DEVELOPMENT HEARING OFFICER
SUPPLEMENTAL SUBMITTAL

PROJECT NO. PR-2022-00710

Application No. SD-2023-00038

**RE: RESPONSE TO DHO COMMENTS MARCH 8TH, 2023
FOR PROPOSED REPLAT TRACT MM-1-B-1 AND TRACT MM-1-B-2 SEVEN BAR RANCH
PR-2022-007100
SD-2023-00038**

Plat of
Tracts MM-1-B-1 and MM-1-B-2
Seven-Bar Ranch
 Town of Alameda Grant, Projected Sections 5 & 8,
 Township 11 North, Range 3 East, N.M.P.M.
 Albuquerque, Bernalillo County, New Mexico
 August 2022

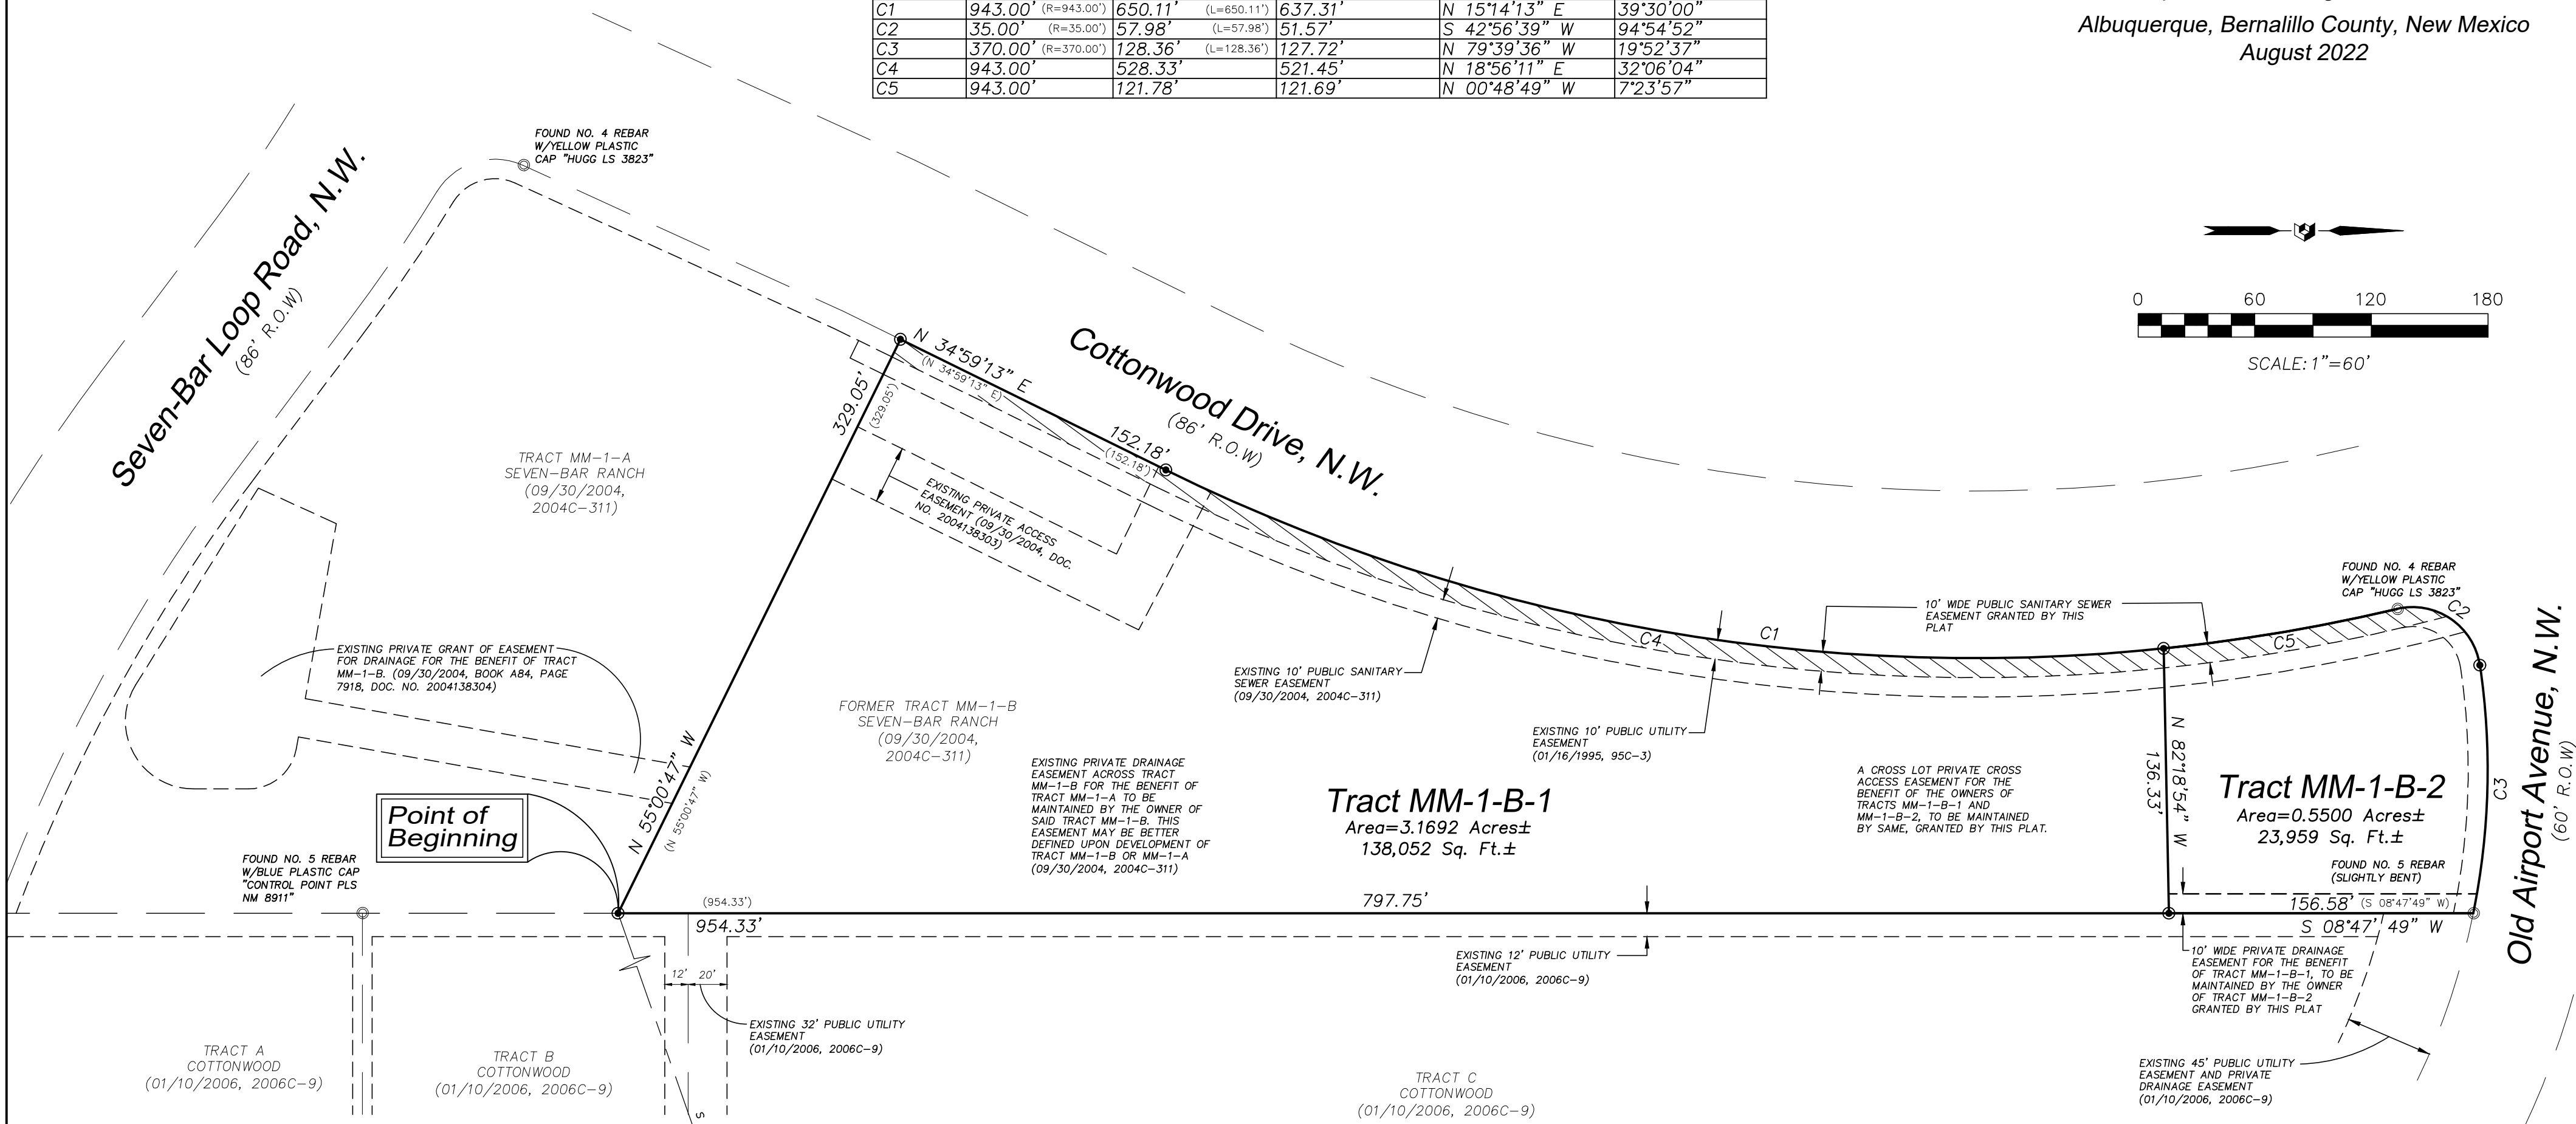
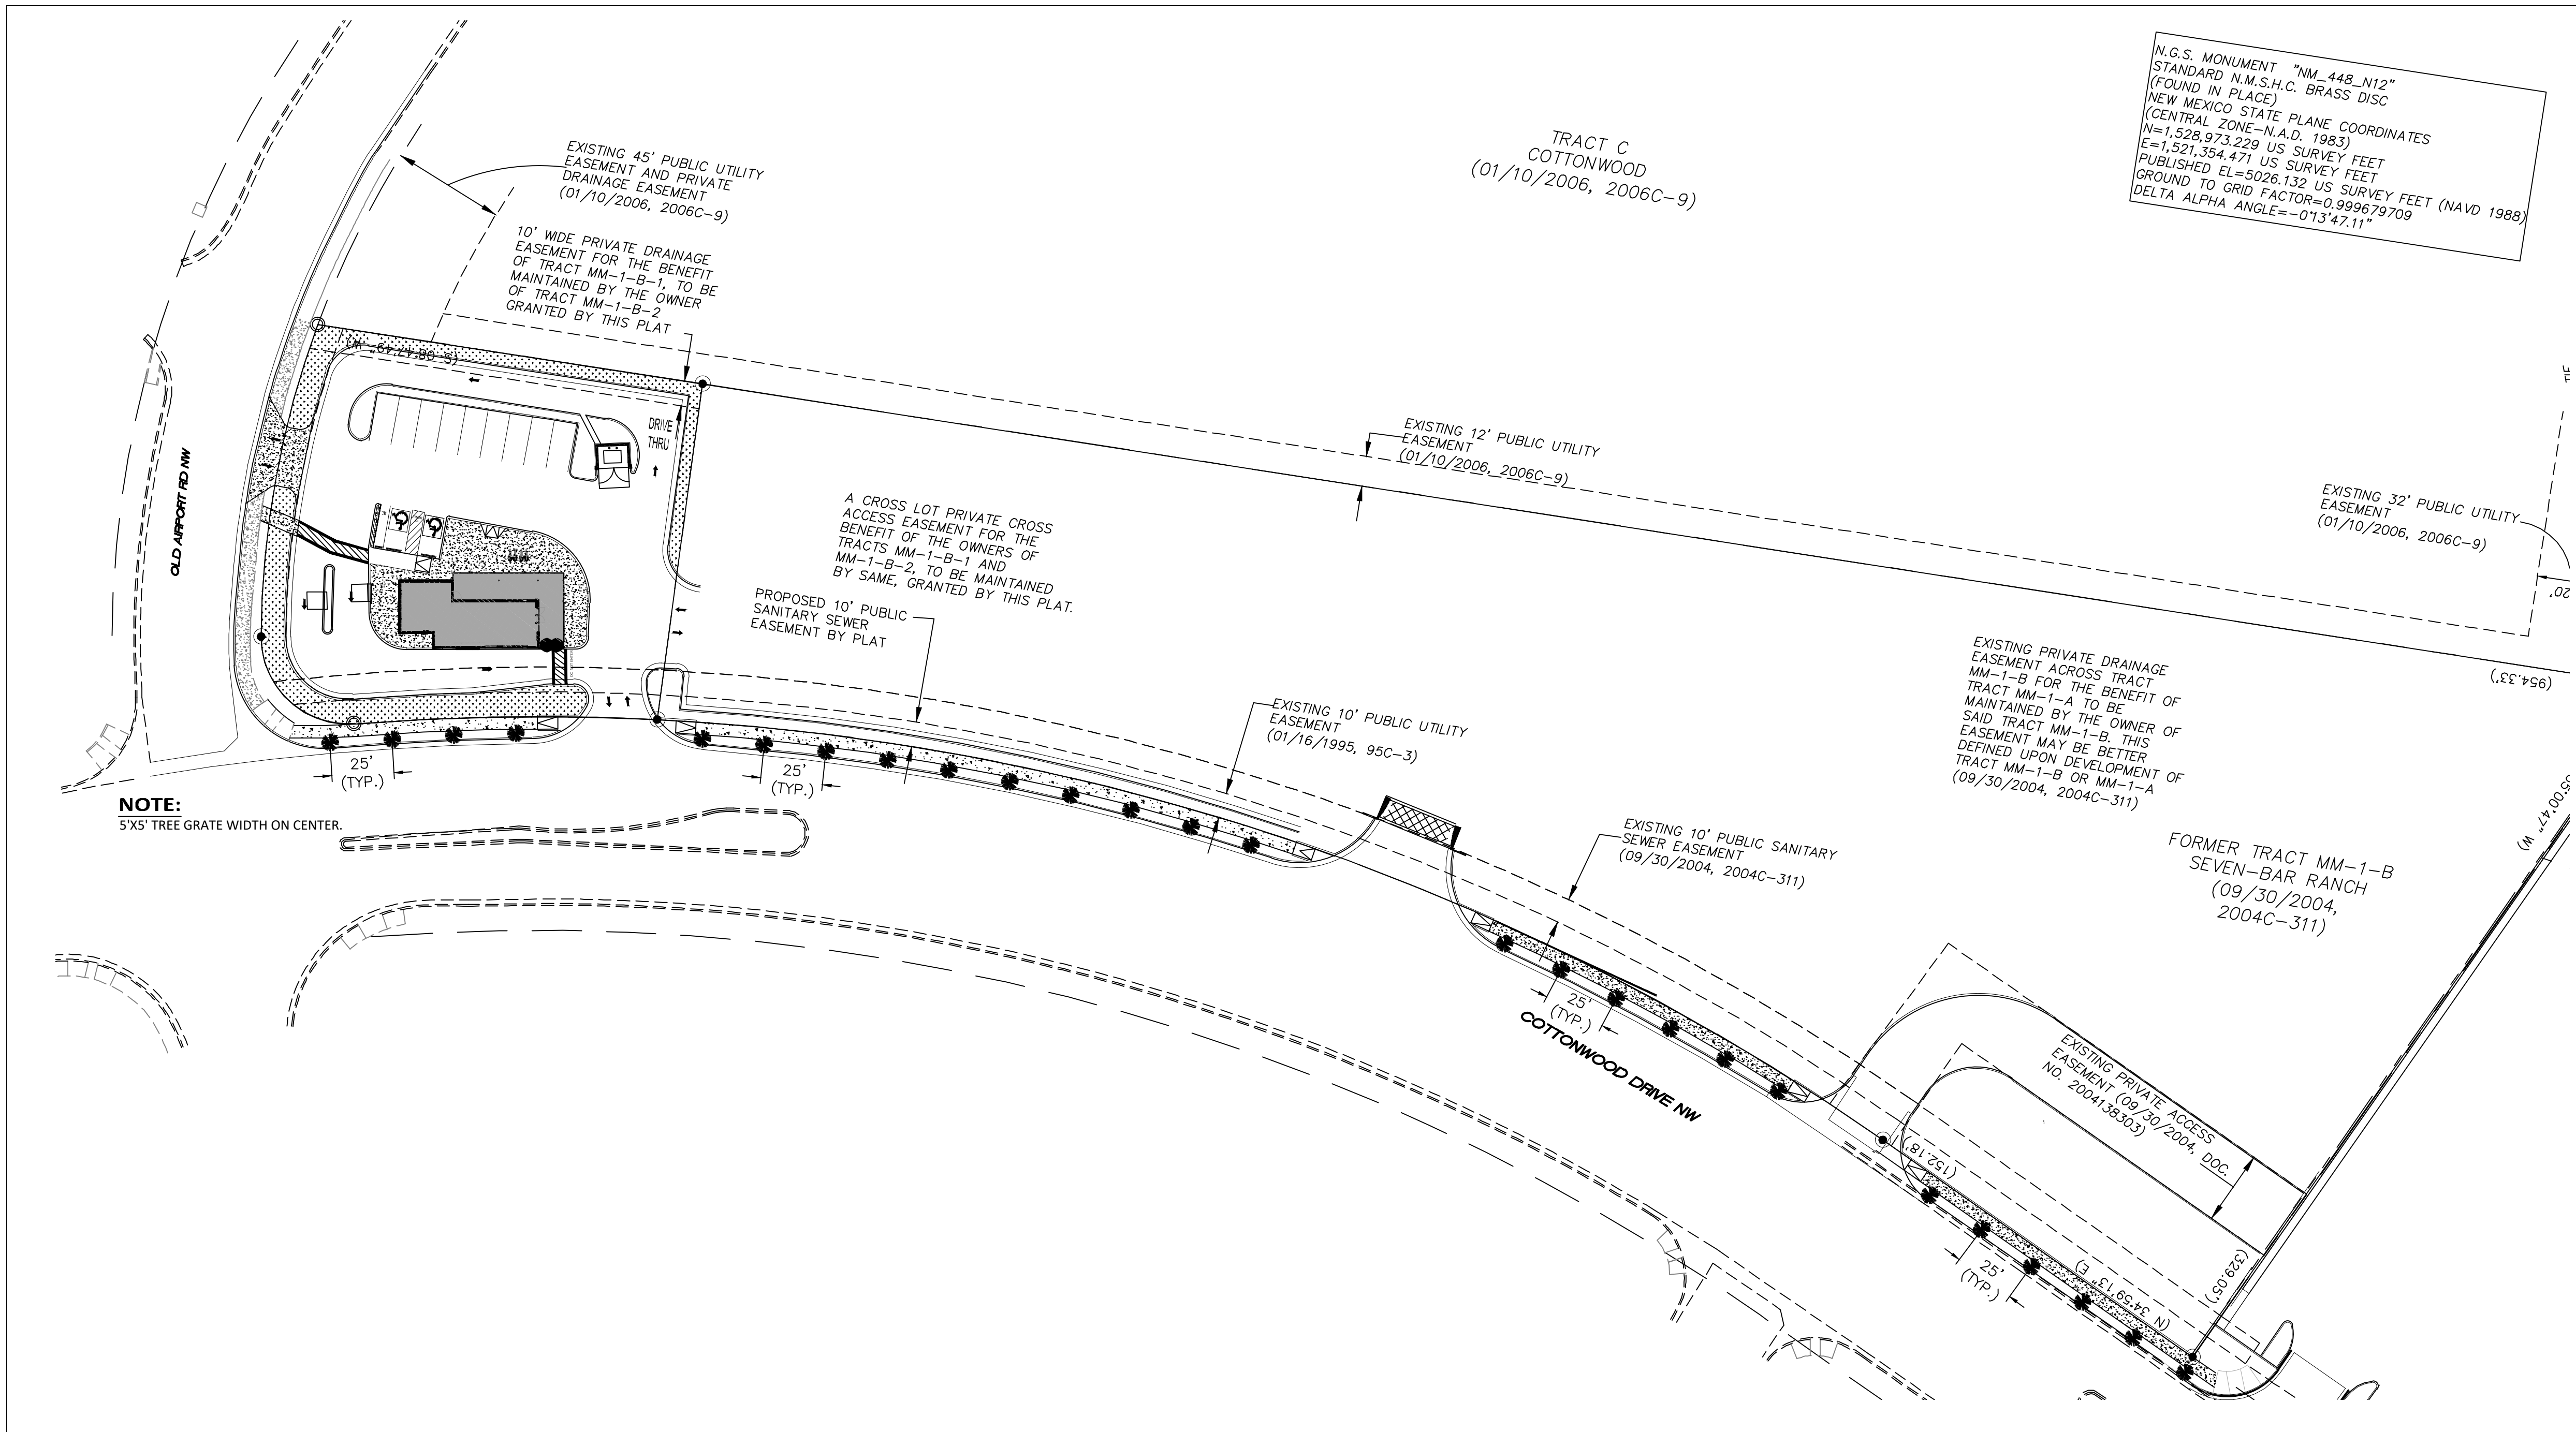
a. The minimum width easement requires is 20'. Please include a 20' easement for the public sanitary sewer line. (Exclusive)

b. Please add the following note

i. ABCWUA Public Water & Sanitary Sewer Easements Albuquerque Bernalillo County Water Utility Authority (ABCWUA) is granted easement(s) in the dimensions noted on this plat for the construction, installation, maintenance, repair, modification, replacement and operation of public water and sanitary service lines, equipment and facilities reasonably necessary to provide service together with free access on and over the easement and the right to remove trees, shrubs, undergrowth and any other obstacles, modifications, or structures which interfere with use of the easement.

4. Incorporate shared access with neighboring property as needed, and radius for entry drive off of roadway should not encroach into neighboring property.

RESPONSE: These comments have been added to the Updated Plat. The Plat is provided with DHO submittal and below.

RESPONSE: This has been added to the Plat. The Plat is provided with DHO submittal and below.

FIIZ DRINKS ALBUQUERQUE, NM	DRAWN BY JL
	TREE EXHIBIT	DATE 3-17-2023
TIERRA WEST, LLC 5571 MIDWAY PARK PL NE ALBUQUERQUE, NEW MEXICO 87109 (505) 858-3100 www.tierrawestllc.com		DRAWING
		SHEET # T-1
AMANDA HERRERA P.E. #23575		JOB # 2022048

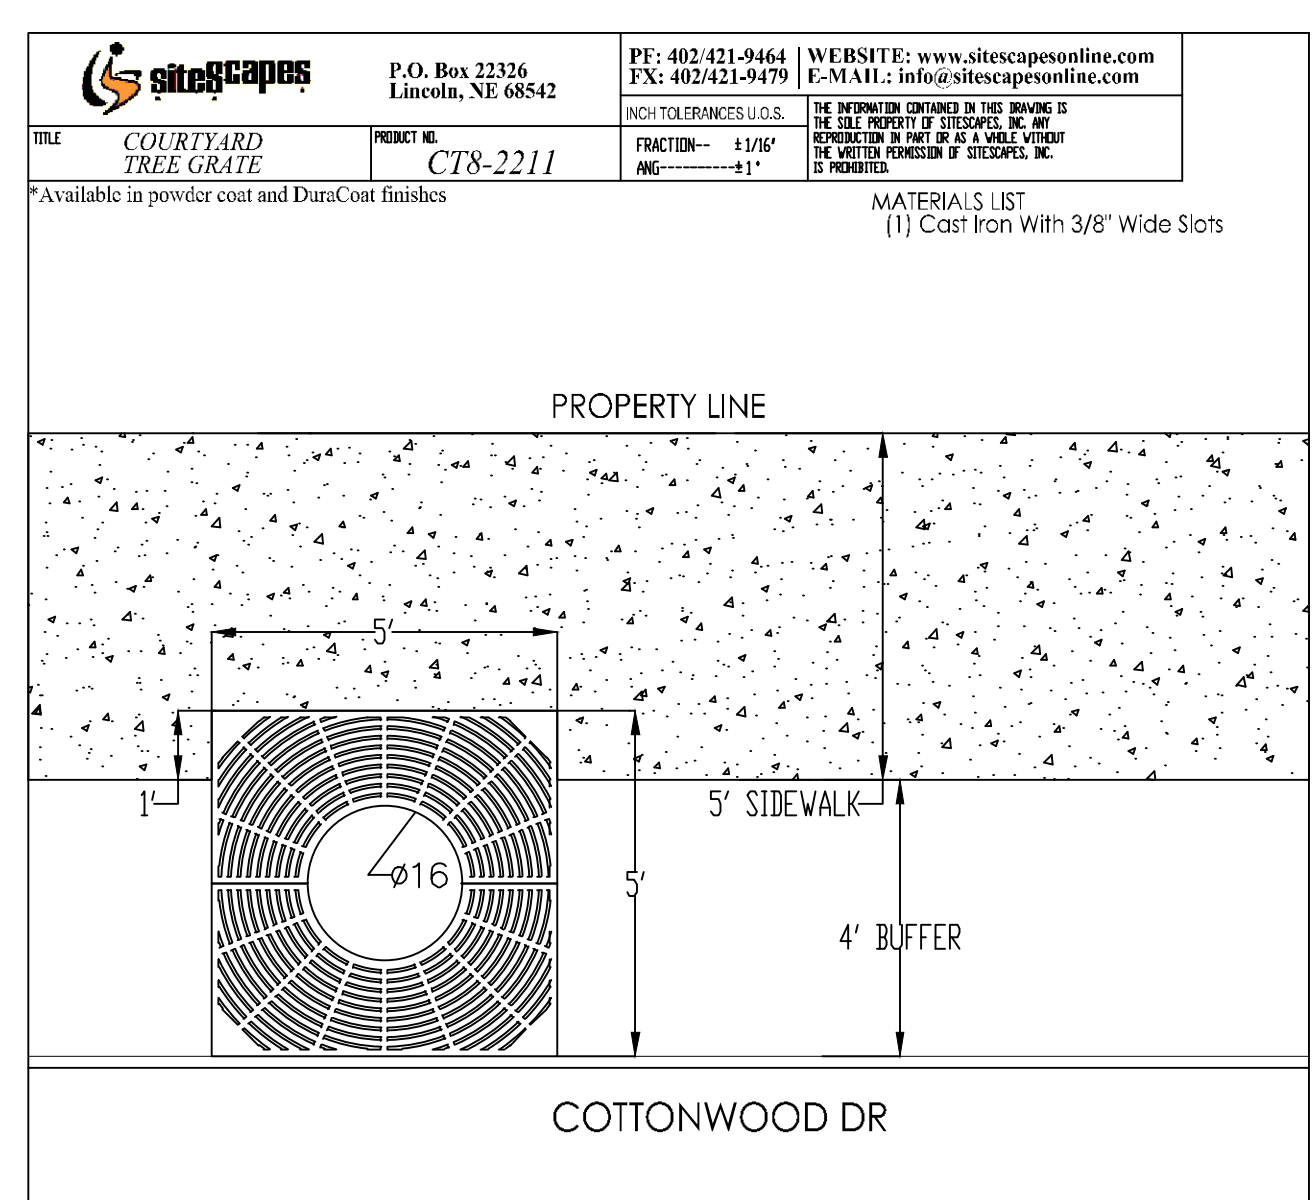
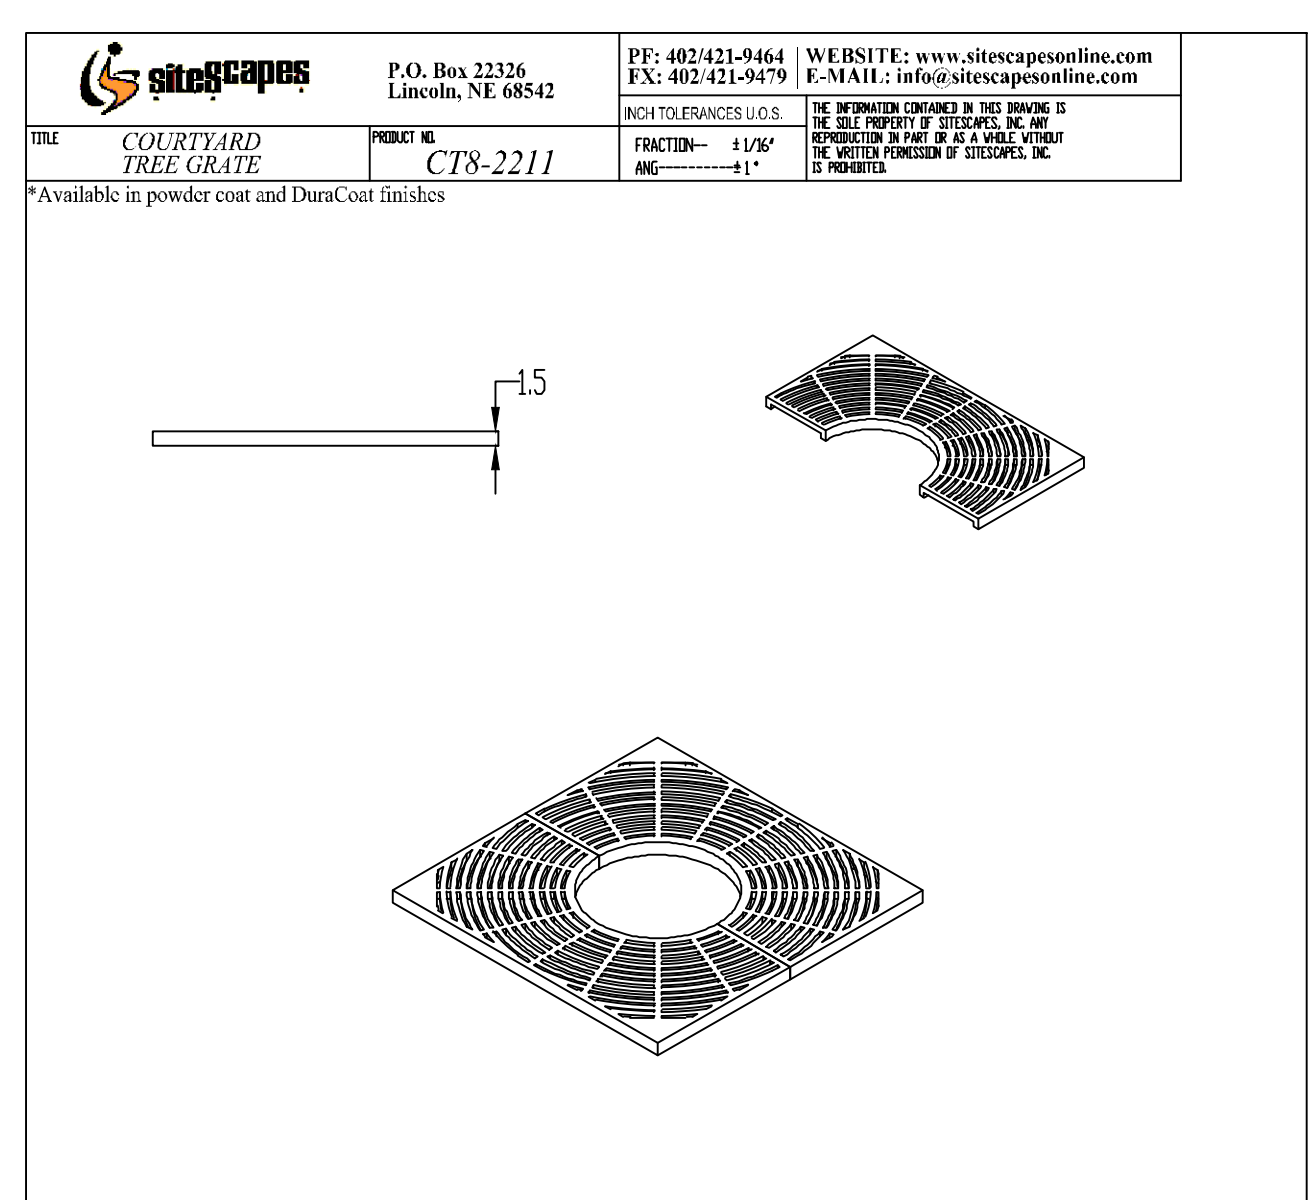
1. Street Trees required per IDO Section 5-6(B). Please consult the NM Climate Ready Tree List: <https://www.nature.org/content/dam/tnc/nature/en/documents/Climate-Ready-Trees-Report-Nov2020.pdf>
RESPONSE: Street Trees will be provided for along the buffered ROW every 25-ft along the Cottonwood Dr and Old Airport Rd. See Tree Exhibit Below with the required 5-ft depth needed for Trees. The Developer of the two Proposed Plats will consult with the NM Climate Ready Tree List for approval of tree's to be used.
2. Park and Recreation has no adverse comments.
